BMP NUMBER: JR048

Project Name: Greensprings West, Phase I
Structure/BMP Name: Lake F Wet Pond (JR048)
Project Location: Centerville Rd at Manorgate Dr.
BMP Location: Manorgate Dr. at Longview Landing
County Plan No.: 46-1S - 18 - 1-1 99

S-18-99; JR048 AS-BUILT DRAWING-1/10/01 SJT REVIEW SET

Designed	Drawn
HWP/CWG	KEG
Scale	Date
1"=50'	2/26/99
Project No.	
8656-1	
Drawing No.	
7 OF 19

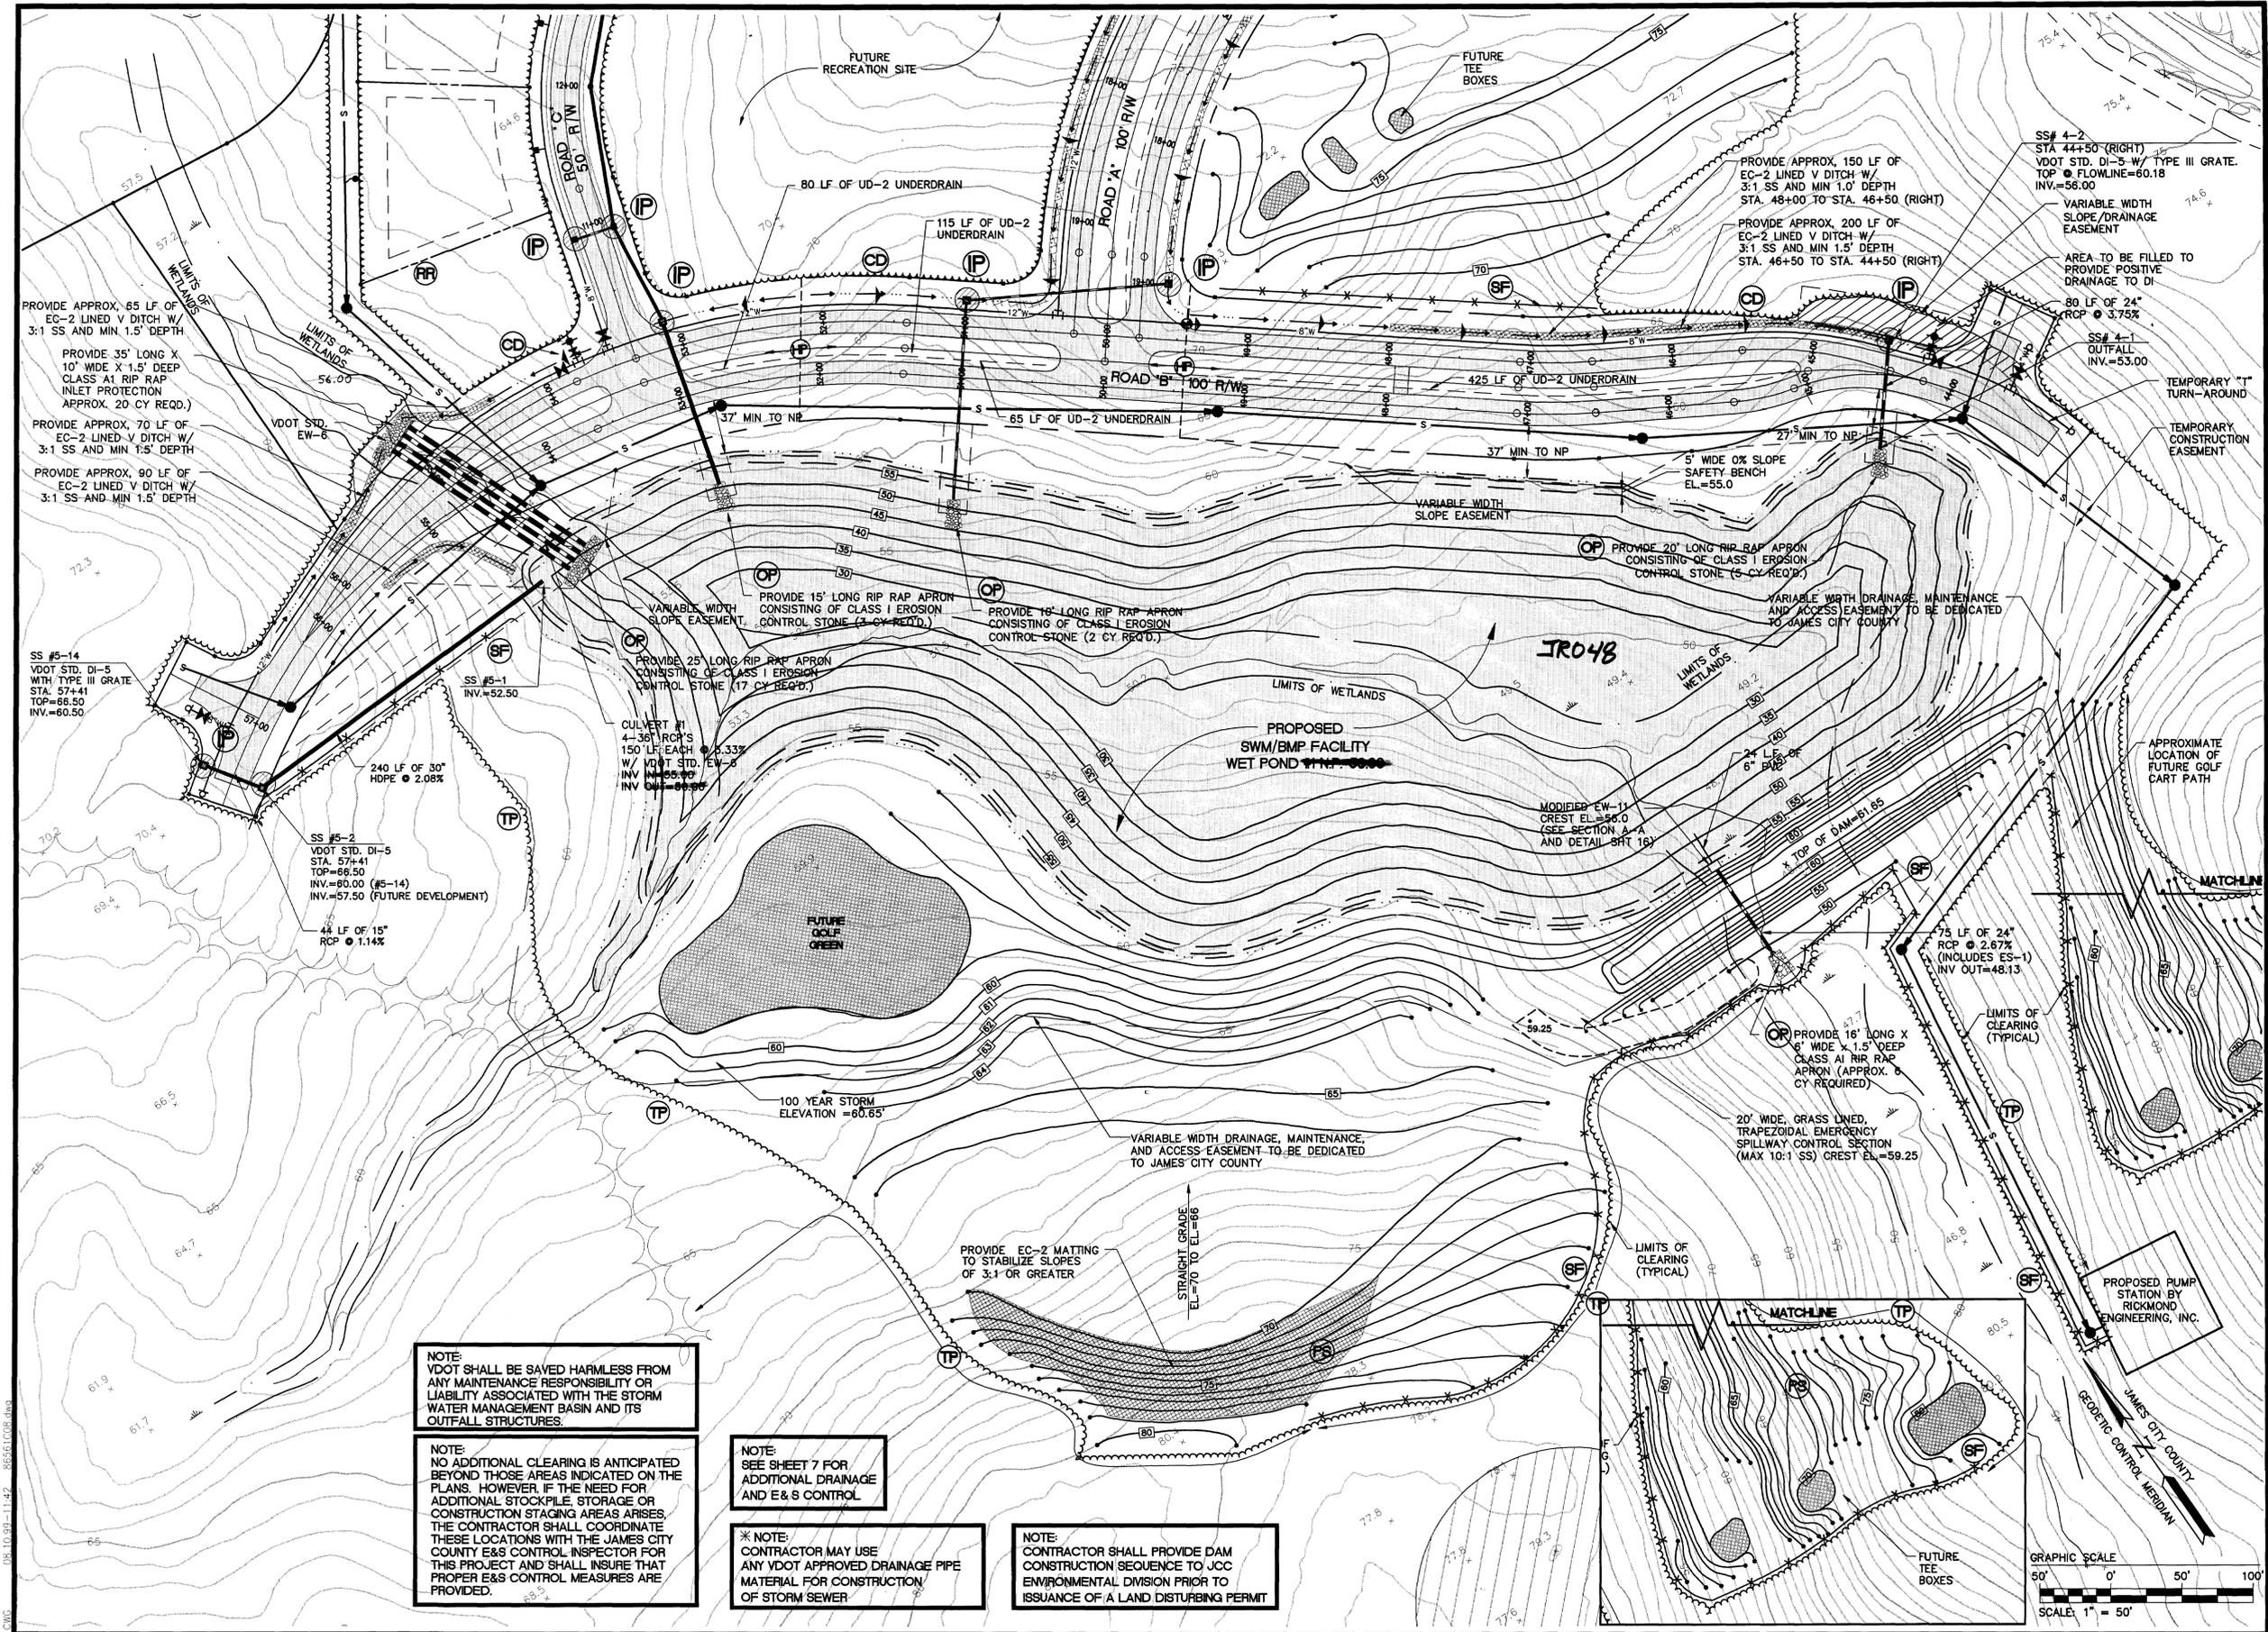
- ✓ 14) There is a note on sheet 7 addressing the soil stockpile area.
- ✓ 15) Proper E & S measures are shown on the plans.
- 16) A construction sequence and narrative are now provided on the plans.

3. Perimeter Controls. Provide a general note on Sheet 5 that diversion dike (DD) and silt fence (SF) perimeter controls as shown on the plan are intended to be placed at/along the Limit of Clearing and Grading. It should not be interpreted that silt fence and diversion dike features as shown on the plan at Lots 127 through 136 are to be installed outside the designated limit of work.

Designed AES	Drawn AES
Scale NONE	Date 2/26/99
Project No. 8656-1	
Drawing No. 17 OF 19

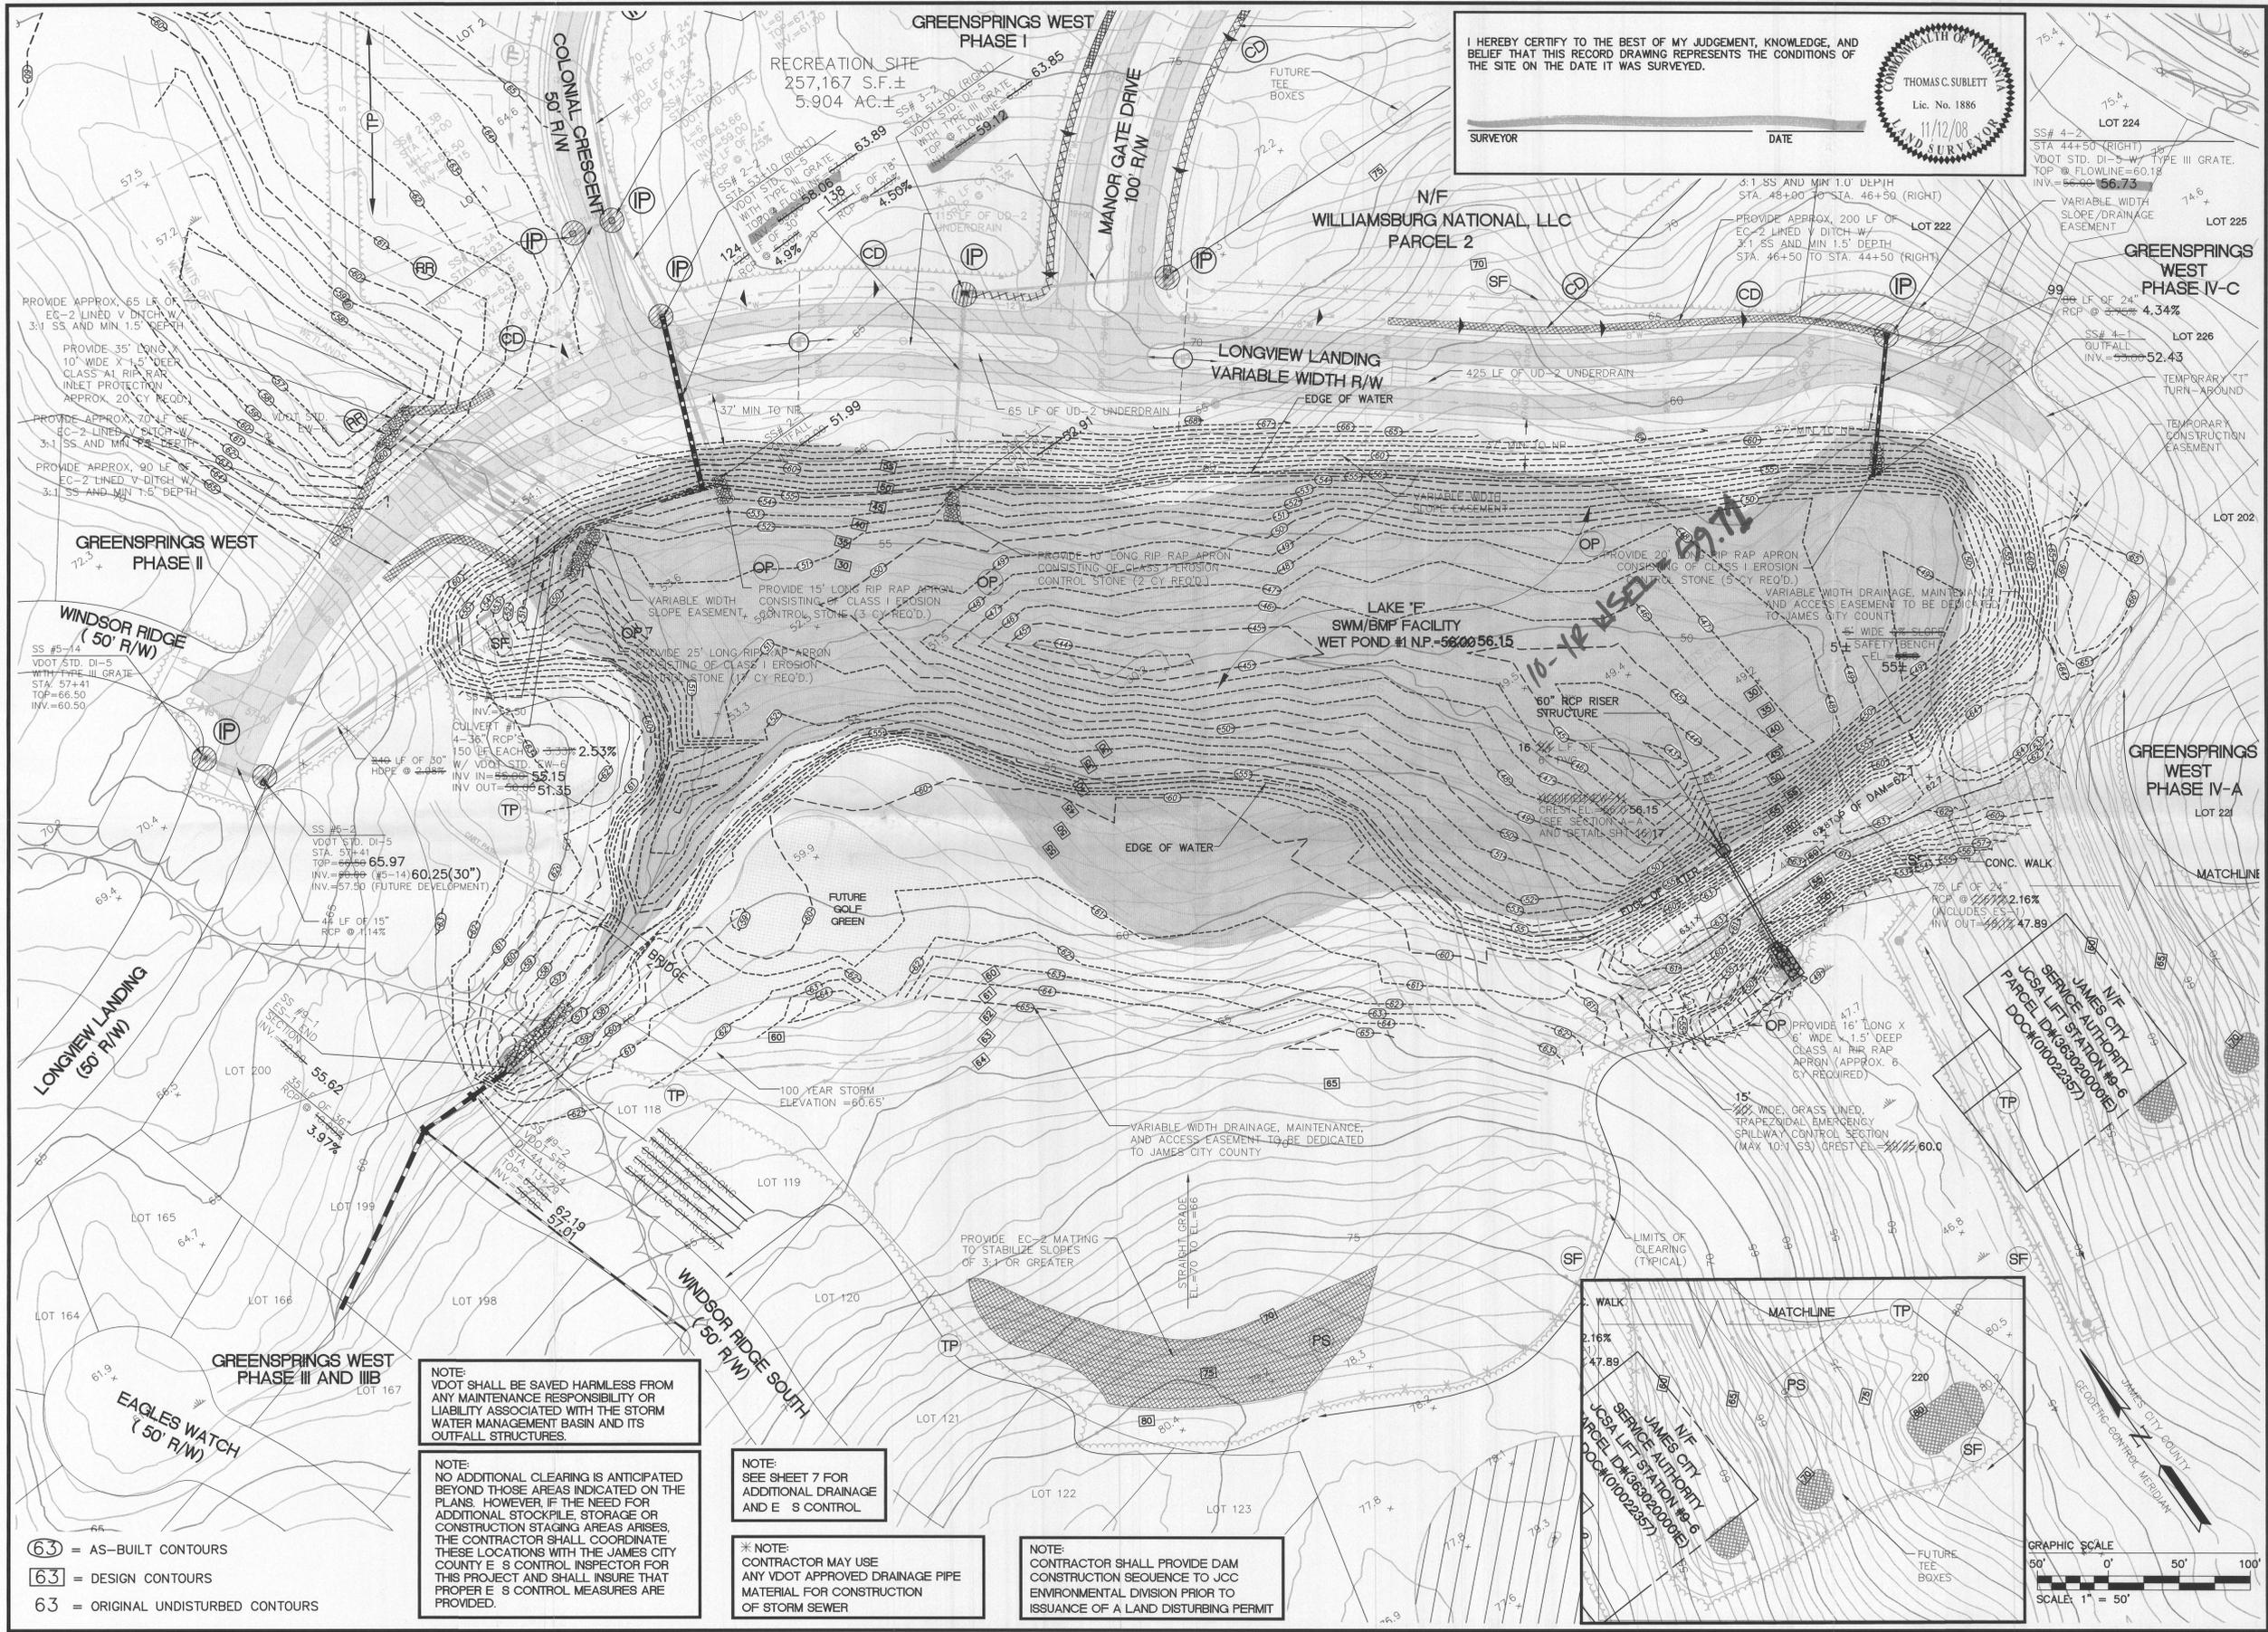
Sheet 7 Sheet 17
- ✓ 17) The top of the emergency spillway is in cut.
- 18) The stormwater management facility will act as a sediment basin during construction.
